# MOOLARBEN COAL COMPLEX UG4 EXTRACTION PLAN - LONGWALLS LW401-408 Reasons for Decision

**EXTRACTION PLAN**

**RE: MOOLARBEN COAL COMPLEX UG4 EXTRACTION PLAN LW401 – 408 – RESPONSE TO REQUEST FOR ADDITIONAL INFORMATION**

**Figure 3:** Site S1MC280 position, relative to longwalls 402 and 403 (direction of longwall retreat is from right to left)

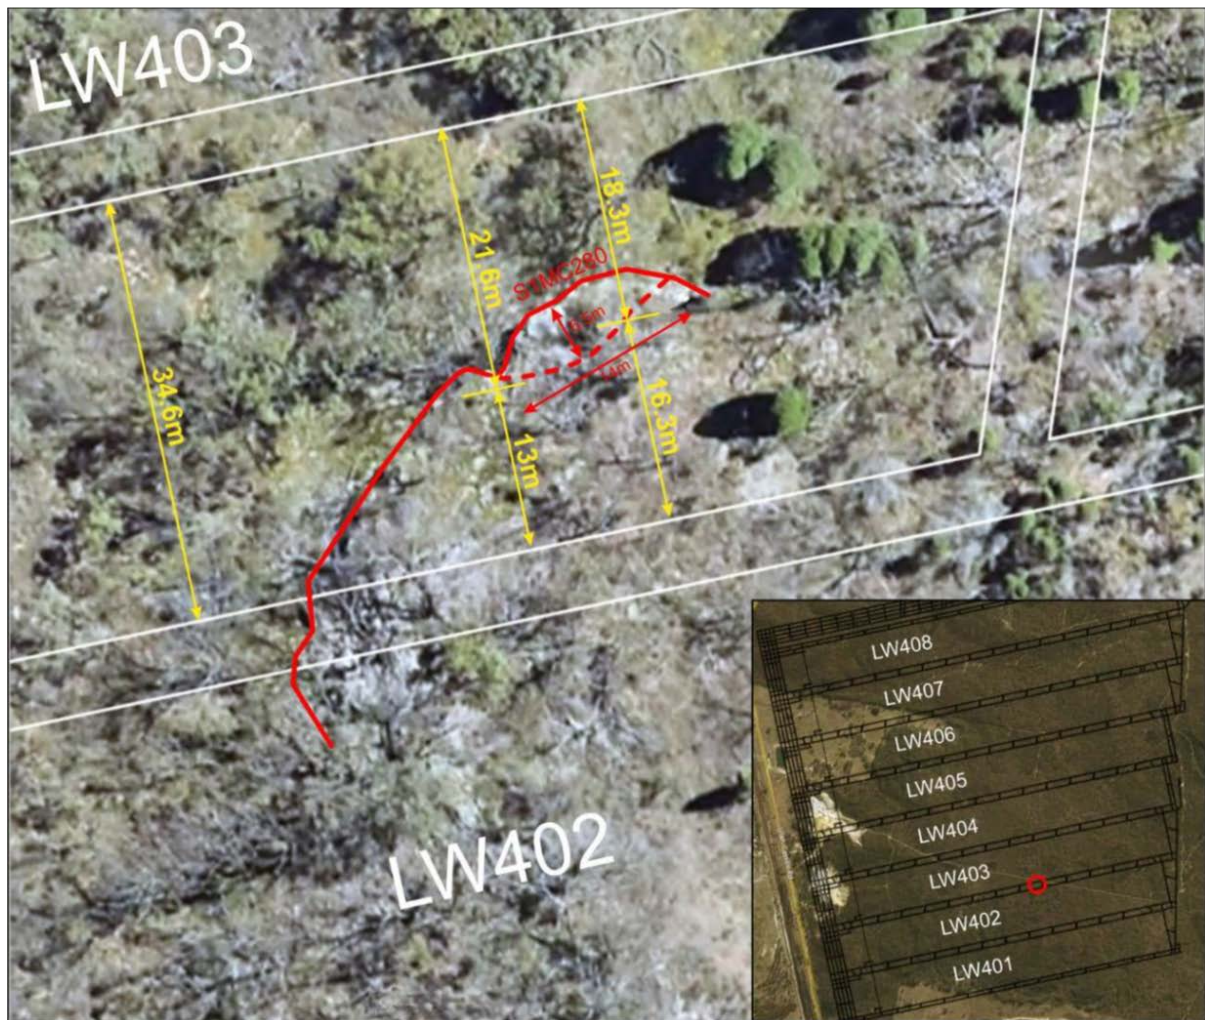
The MSEC subsidence prediction for this site is for a maximum vertical subsidence magnitude of 150mm, a total tilt of 4.0mm/m and a maximum tensile strain of 2mm/m. The Heritage Management Plan notes the following, in relation to these predictions:

The response to this request (22 March 2022) indicates a tilt of 5.0mm/m (presumably towards LW402, or into the hillside behind the rock shelter), as 402 passes. The resultant tilt after 403 then passes the site is then predicted to be 4mm/m (presumably in the opposite direction, or down-slope towards 403). The sense of these tilt values is yet to be confirmed by the Applicant/MSEC, but if this interpretation is correct, it would suggest an incremental rotation of the rock shelter of up to 9mm/m towards the down-slope direction, between the passing of 402, and when 403 has passed. Based on a plan provided by the Applicant (11.04.22), the maximum depth of the rock shelter overhang is approaching 6m+. This would result in a net incremental rotation of up to 54mm.

The Panel has serious concerns about the ability of the rock shelter overhang to withstand these levels of incremental tilt, especially when combined with some degree of potential cracking and/or shearing. The Panel therefore recommends that the Applicant should develop a mining plan, as part of the overall mitigation strategy for the site, to create a reduction in the panel

- b) Establish a comprehensive TARP for both the “early warning” site listed in (a) above, and for monitoring at the rock shelter.
- c) Provide a comprehensive mitigation plan for the site, to cover all actions to prevent any significant cracking or instability of the shelter due to subsidence, tilt or strain. This should include the planned stress-relief slotting design; consideration of temporary support of the overhang; and design of a LW403 Panel face shortening, to leave some additional coal in the vicinity of the site. This mitigation plan should also be linked to the above TARPs.

**Figure 4:** Surface geology and known structures

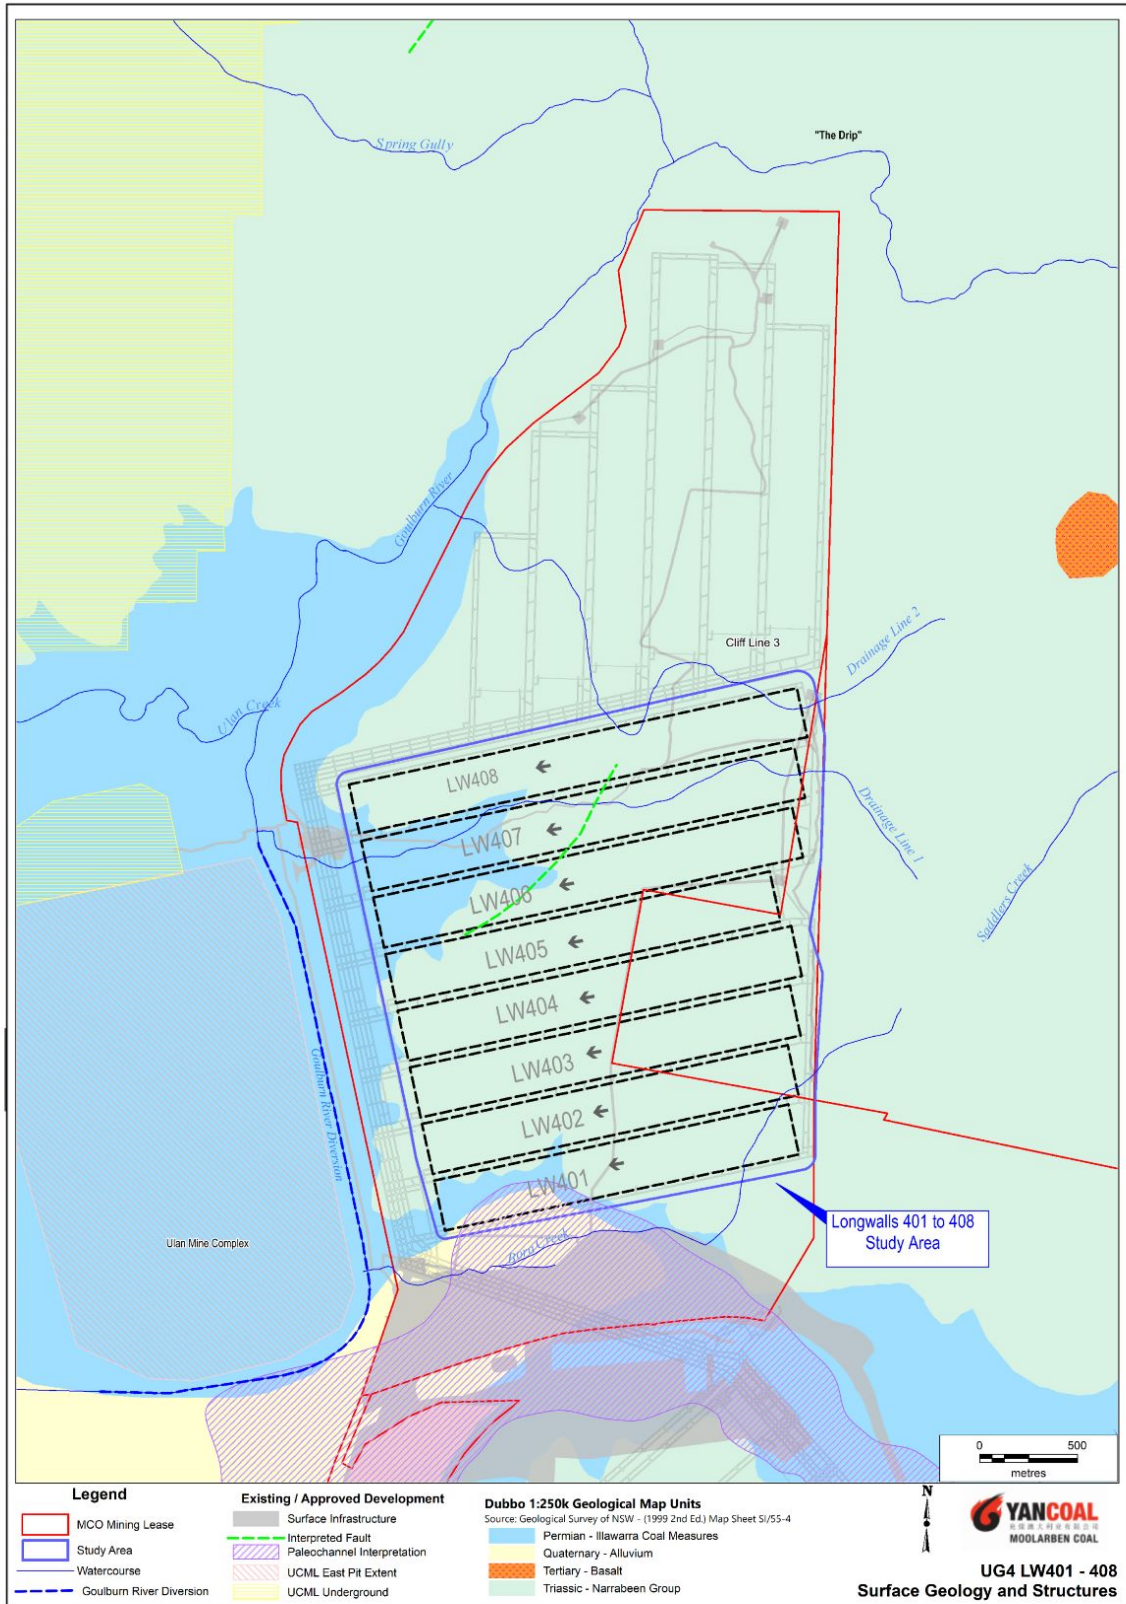
The surficial extent of these geologies is shown on Figure 4. While the mapped geology is well known there is minimal detail regarding structural features (such faults, fractures, and lineaments) across the UG4 area and adjacent areas. The only mapped and identified feature to date is an inferred fault extending from the south-western portion of LW406 through to the

central portion of LW408 and trending in a north-easterly direction (see Figure 4). Such features can enhance or restrict groundwater migration and flow.

- An interim report on the geological structure and potential implications for groundwater impacts be supplied to the Department no later than 30 June 2022. Based on this report the Panel may provide further advice on additional groundwater monitoring or the siting of proposed monitoring bores (see Section 4.3.3)

**Figure 5:** Existing and proposed environmental monitoring locations (from Yancoal, 2022)

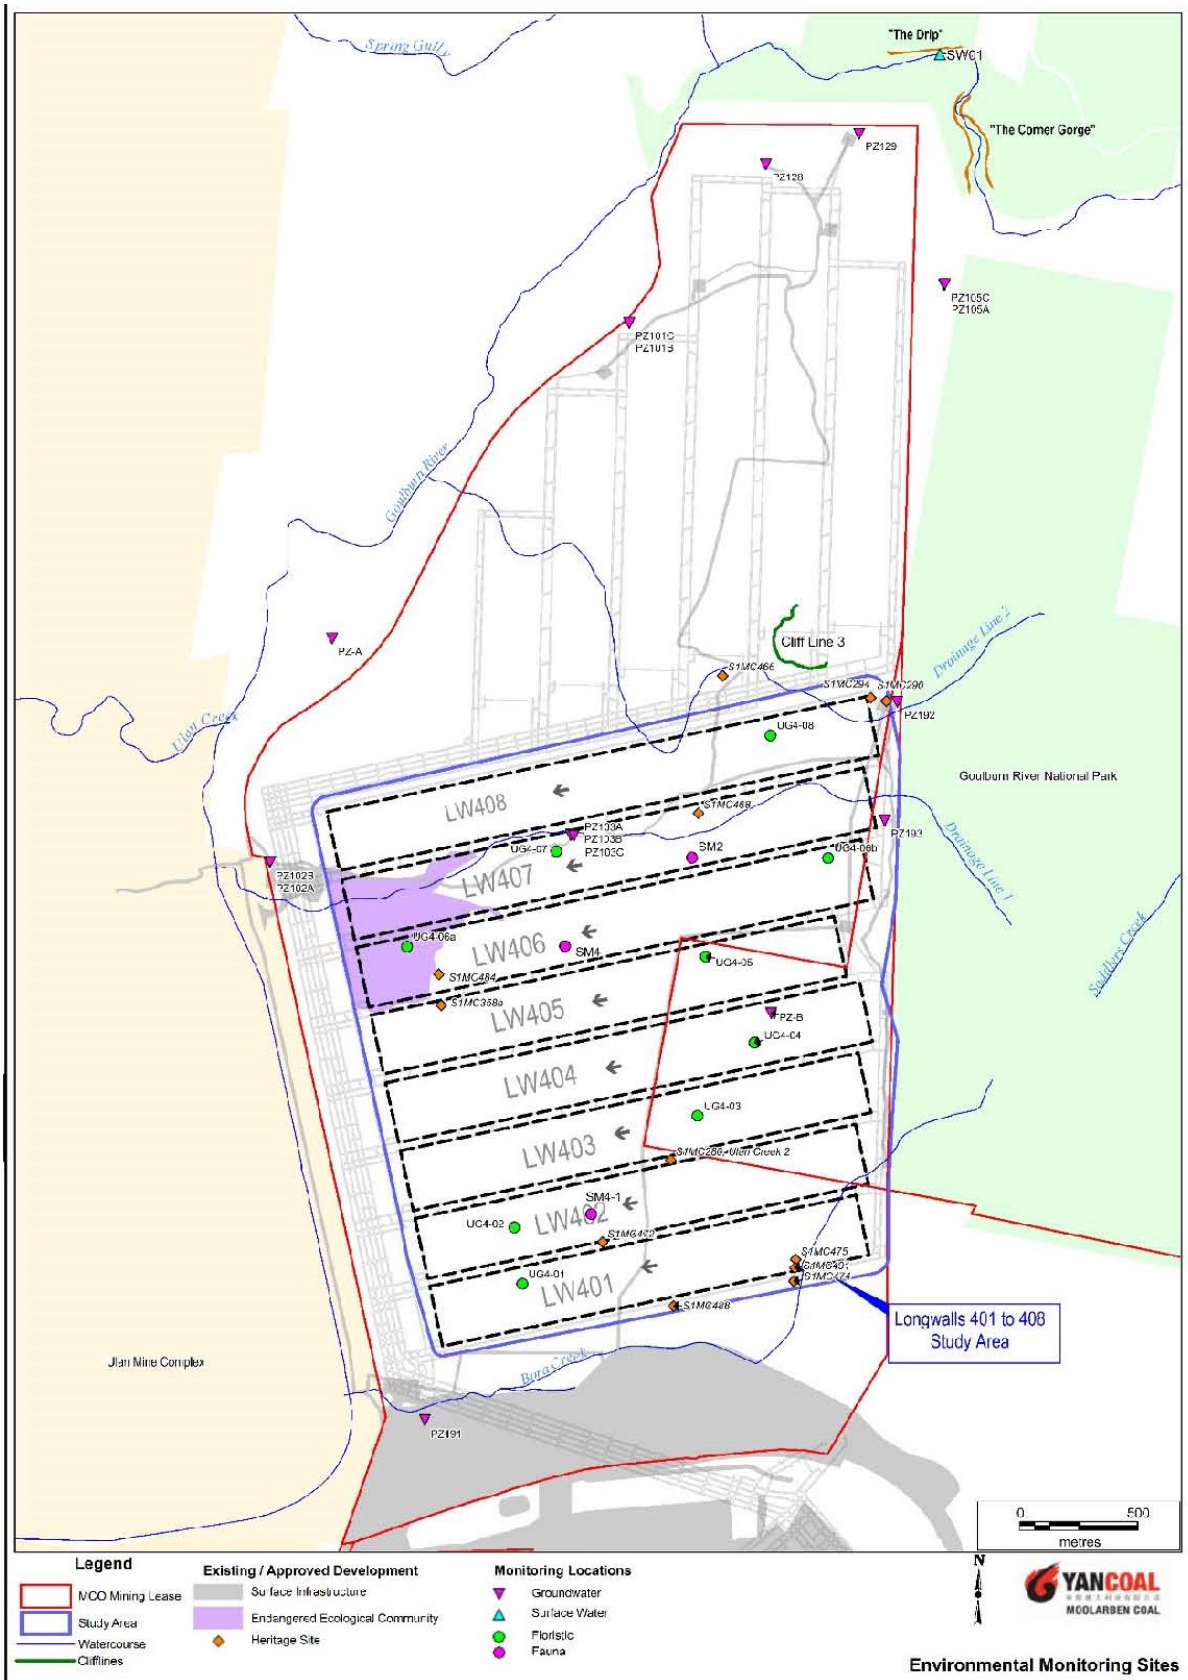
The Panel supports additional groundwater monitoring locations and recommends extra nested sites in addition to those proposed in the Extraction Plan. The Panel's comments on the nominated sites are:

13. Install additional groundwater monitoring bores at six sites (in addition to those nominated by the Applicant in the Extraction Plan):
  - i. Nested dual standpipes (two sites) (each monitoring lower Triassic sandstone and Permian ICM overburden) along the eastern boundary of UG4, ideally at the start of LW401 and LW403

**Figure 6:** Triassic sandstone saturated extent and groundwater contours (2011)

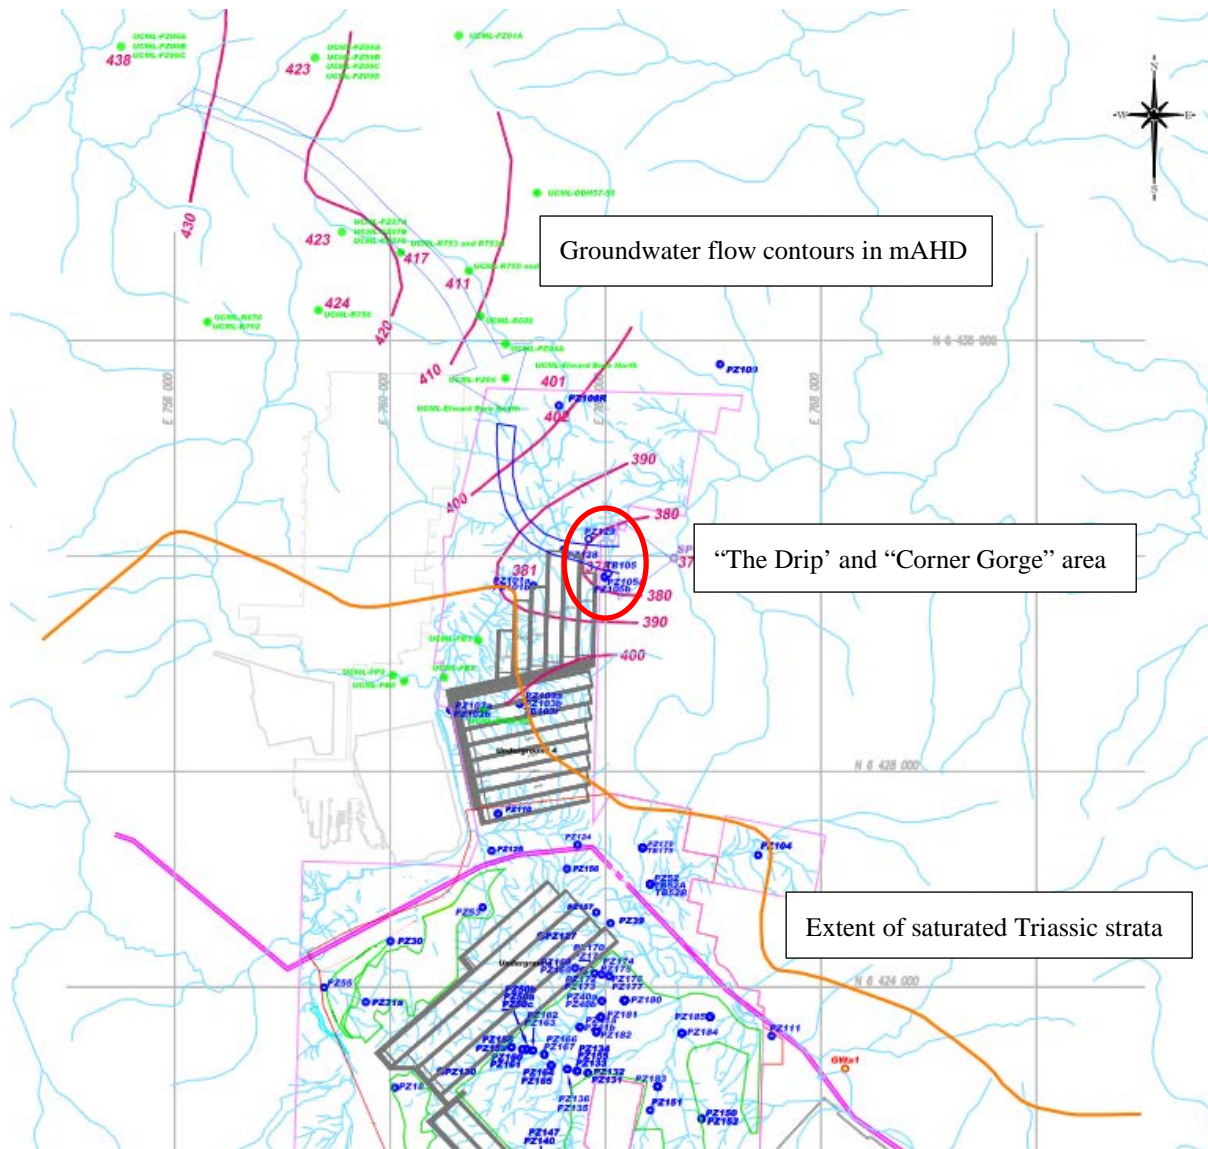
There is a lack of data in the vicinity of LW401 to 408 to properly define the saturated extent of Triassic sandstone and the current groundwater flow contours. Based on limited 2011 site data, Figure 6 (reproduced from RPS Aquaterra 2011) shows the extent of saturated Triassic strata and the groundwater level contours for the sandstone aquifer at that time.

**Figure 8:** Triassic sandstone aquifer water levels to January 2021

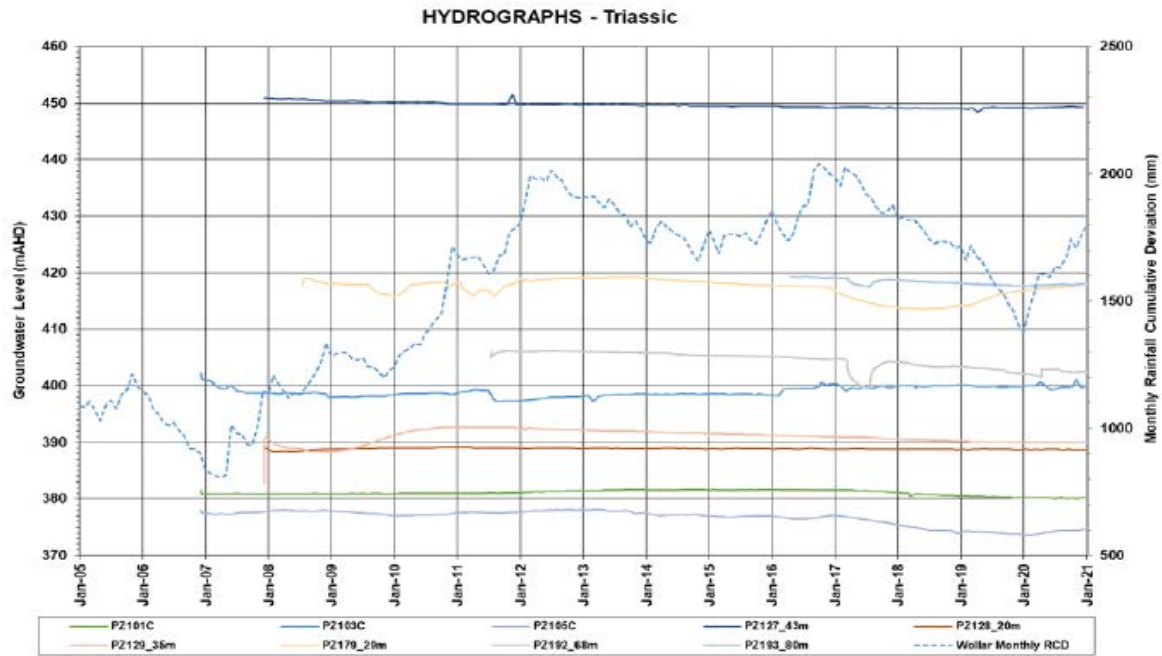
Based on the hydrographs presented in the 2020 AEMR (Yancoal 2021c) (see Figure 8), mostly seasonal variations in water levels are evident in the Triassic sandstone aquifers in the vicinity of LW401 to 408 and towards “The Drip”. The small declines in Triassic sandstone water levels at PZ192 and PZ193 in 2017 are the result of dewatering trials when 50ML of groundwater was pumped from MPB103.

**Figure 9:** Permian aquifer water levels at selected sites to January 2022

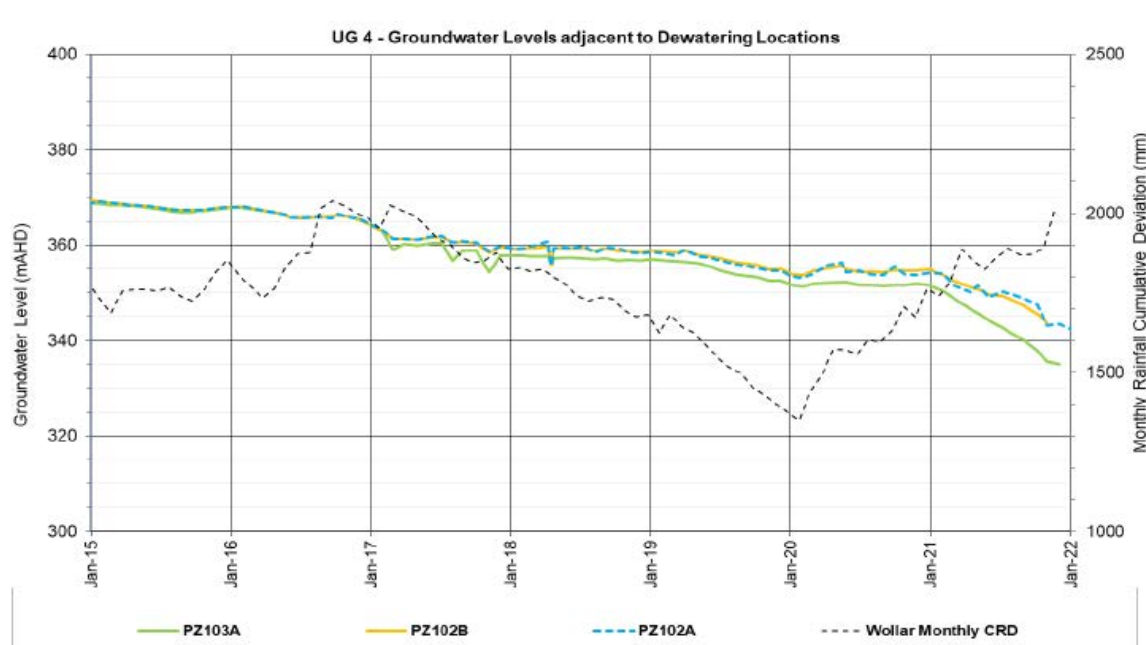
There is also insufficient site data to produce Permian overburden and Permian Ulan Seam water level contours for the UG4 area and to confirm flow directions and connectivity with the overlying Triassic sandstone aquifer. The recently supplied hydrograph (from Yancoal 2022) showing 15-20m declines in water levels in the deep Permian aquifers during 2021 at the PZ102 and PZ103 sites (Figure 9) is concerning. These two sites are located above and adjacent to LW407 and LW408 and emphasise the need for additional nested monitoring sites prior to the commencement of mining in the UG4 area. It is unclear whether these recent trends are Moolarben Coal Complex (MCC) or Ulan Coal Complex (UCC) related.

**Figure 10:** Drainage lines, surface water monitoring locations and layout of proposed longwalls in UG4 (Figure 4 of Yancoal 2021d)

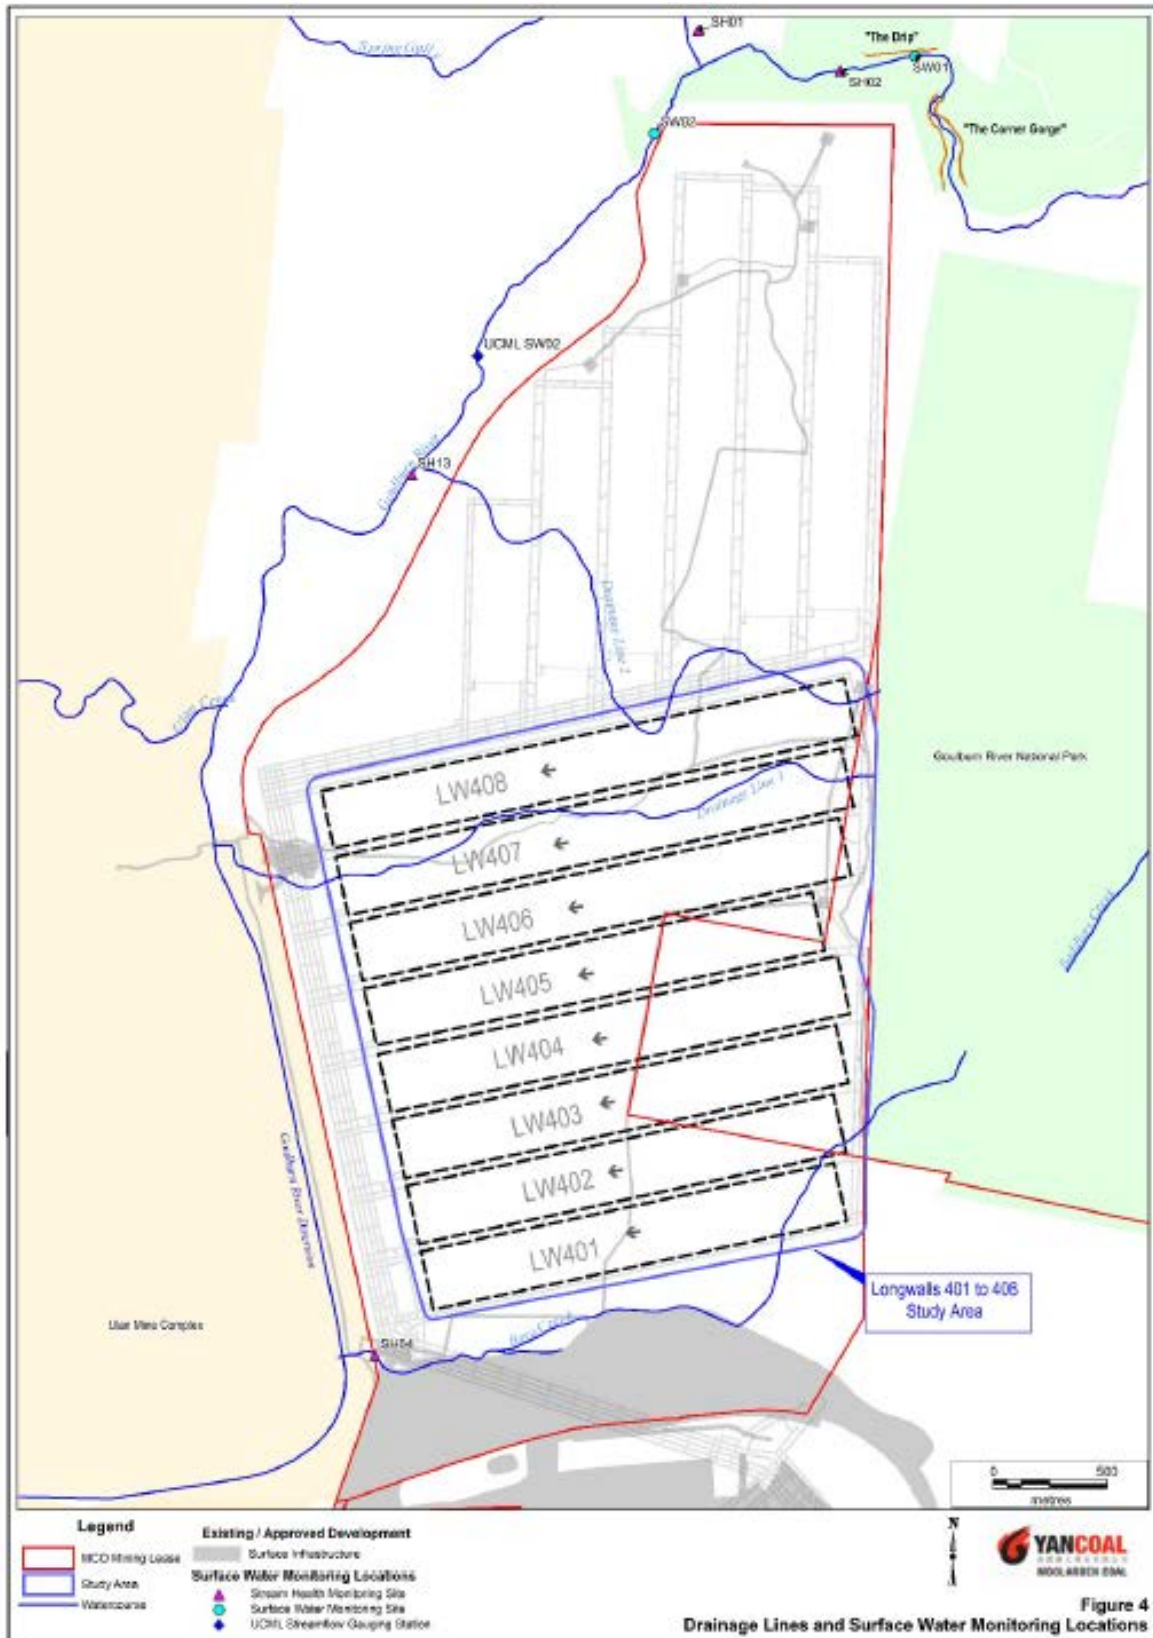
Figure 10 below shows the UG4 mining area, drainage lines and surface water monitoring sites. The identified low-order watercourses affected by LWs 401-408 are Bora Creek and Drainage Lines 1 and 2 (Figure 10). The regionally significant affected watercourse is the Goulburn River.

For Drainage Lines 1 and 2, considerable effort is planned for baseline and impact monitoring but no TARPs are in place. TARPs should be proposed for water quality, with the purpose of identifying and managing significant adverse impacts on water quality of discharges to the Goulburn River.

19. If the Extraction Plan is approved, conditions should include increased monitoring of the Goulburn River and Drainage Lines 1 and 2 following consultation with National Parks. The monitoring should include the following:

20. If the Extraction Plan is approved, conditions should include an extended set of performance indicators and TARPs for the Goulburn River and drainage lines including:
